ST10F276E, ST10F275E, ST10F273E Errata sheet

16-bit MCUs with
512/768/832 KByte Flash and 36/36/68 KByte RAM memories

This errata sheet describes all the functional and electrical problems known in the Cxx silicon versions of the ST10F276E, ST10F275E and ST10F273E.

Figure 1. Calibration mechanism (during bit 9 comparison phase)

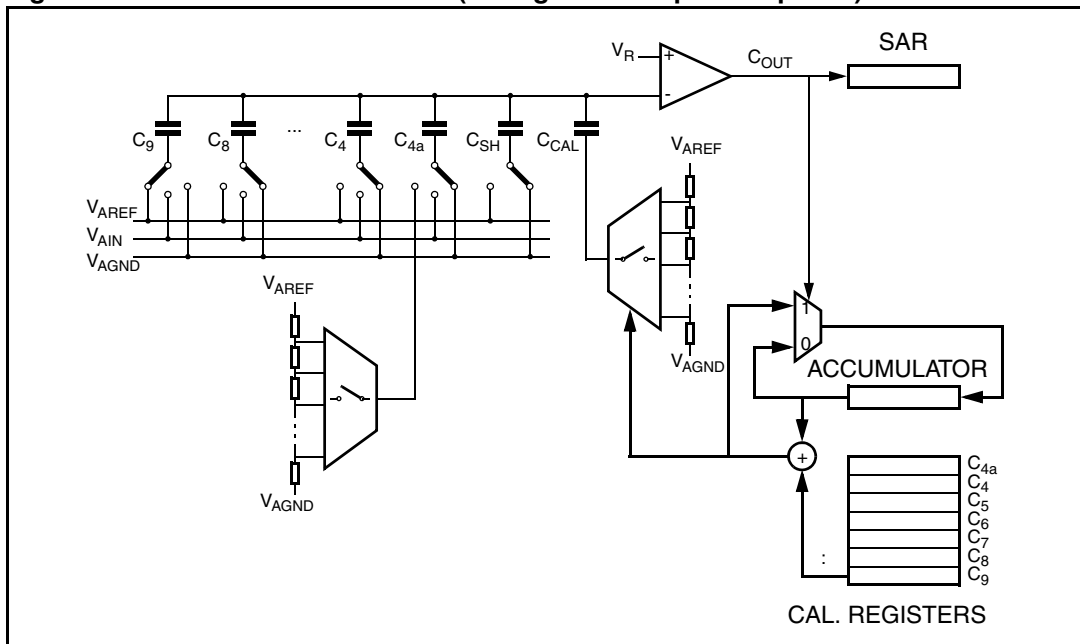
On specific analog input values an accuracy degradation of several LSBs may be seen on the digital output value of the implemented ADC. In particular this occurs if the input voltage matches the internal comparator thresholds, which is when a roll over from the least significant bits (i.e. 0x1Fh -> 0x20h or vice versa) occurs.

The maximum deviation in accuracy is $\pm 250\text{mV}$ over the entire conversion range.

The failure is linked to the implemented “self calibrating circuitry” which is summarized in the [Figure 1: Calibration mechanism \(during bit 9 comparison phase\)](#).

The maximum correction applied by the calibration is 250mV.

When the analog input voltage is close to one of the thresholds of the comparator (by less than 1mV), then the amplifier sees a differential voltage very close to zero. As a result, the output of the comparator will be fluctuating between the values “0” or “1”. Because of the parallel use of the comparator output and of the fluctuating value, different values may be latched in the SAR (Successive Approximation Register) and the Calibration section. As a result a bad calibration mechanism is applied to the successive bit

It is not possible to define a workaround generic for all applications.

Figure 3. ADC injection actual operation

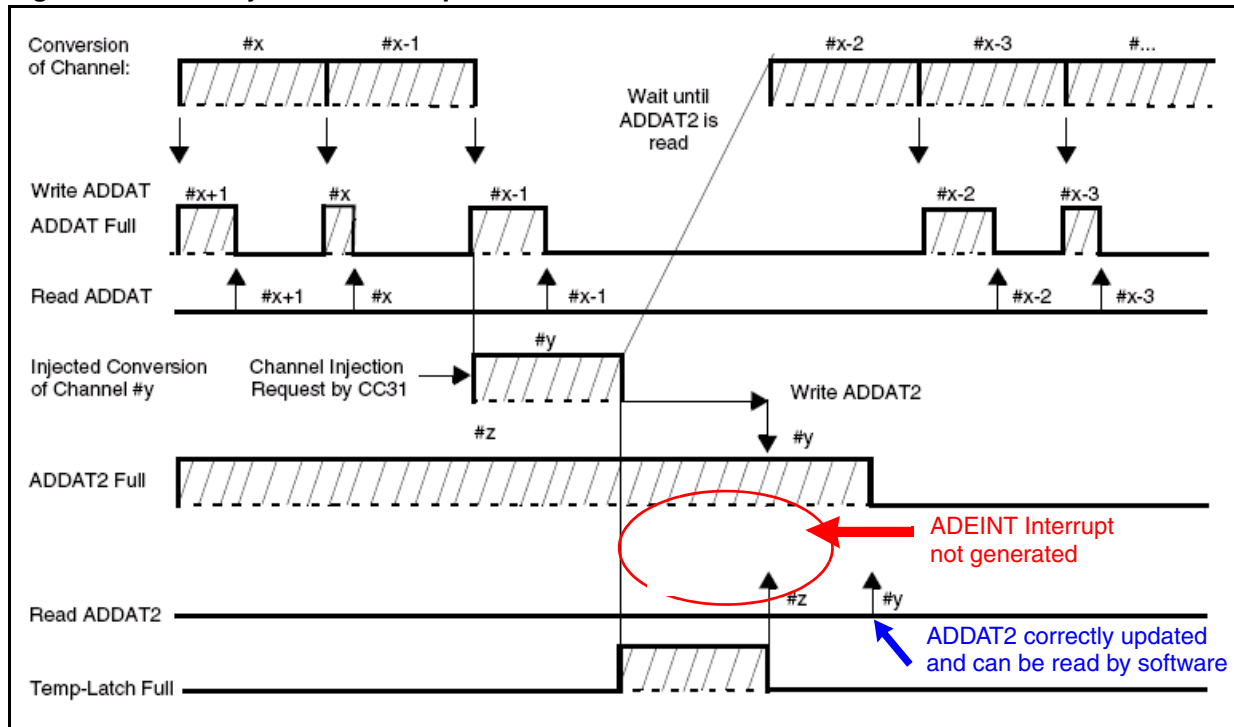
Whenever a new Injection request is issued before the ADDAT2 register has been read by the CPU (i.e. the result of the previous injection request was not read), the ADC is stalled and no further conversions are performed.

For a correct functionality as soon as ADDAT2 register is read then the last converted value should be moved from temporary register to ADDAT2 and the ADEINT interrupt request should be issued. This would allow the CPU to read the last converted value. See [Figure 2](#).

In the real situation as soon as ADDAT2 register is read then the last converted value is correctly moved from temporary register to ADDAT2 but **the ADEINT interrupt request is not received by the Interrupt Controller (see [Figure 3](#))**. As a consequence the CPU/PEC will never know that a new converted value is ready to be read in ADDAT2 register and therefore at the following injection request the ADC will fill the temporary register again (without generating any ADEINT interrupt request) and then will stall the ADC for any further conversion. The ADC will stay in the “wait for read ADDAT2 register” condition forever.

1. Read the ADDAT2 register twice at the end of every injected conversion (also prevents stall condition to occur)
2. Disable then re-enable the Wait For Read mode

Figure 4. ST10 in slave mode

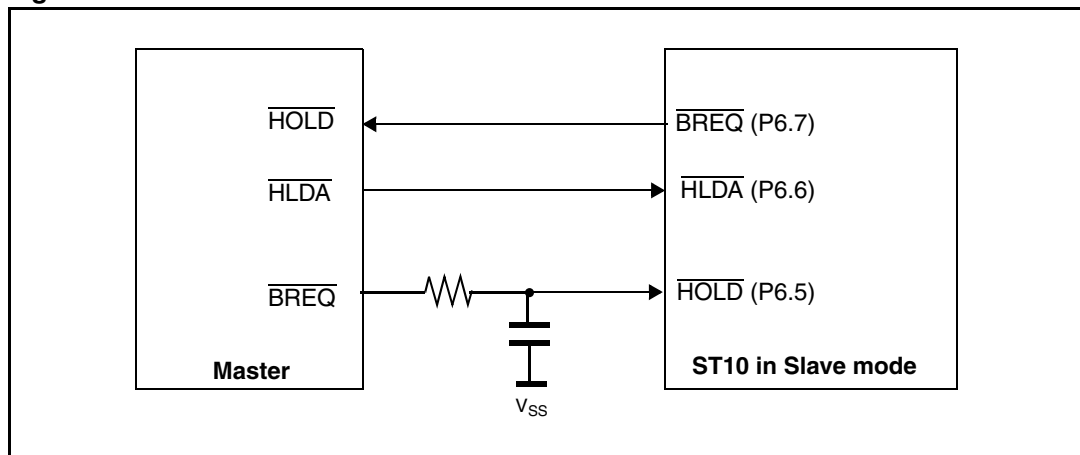
When using external bus arbitration via HOLD-function with the ST10F276 configured as a slave, sporadic bus errors may occurs.

After the slave has been granted the bus, the slave deactivates BREQ sporadically for a short time, even though the bus access of the slave has not been completed. The master then starts its own bus access, leading to a bus conflict between master and slave.

In order not to produce any spurious BREQ pulse during a Slave External Bus Arbitration Phase, it is necessary to guarantee that the distance between the HOLDA assertion (Bus Acknowledge from Master device) and the following HOLD falling edge (Bus Request from Master) is greater than three clock cycles.

This can be implemented by delaying the HOLD signal with a RC circuit as shown in the figure below.
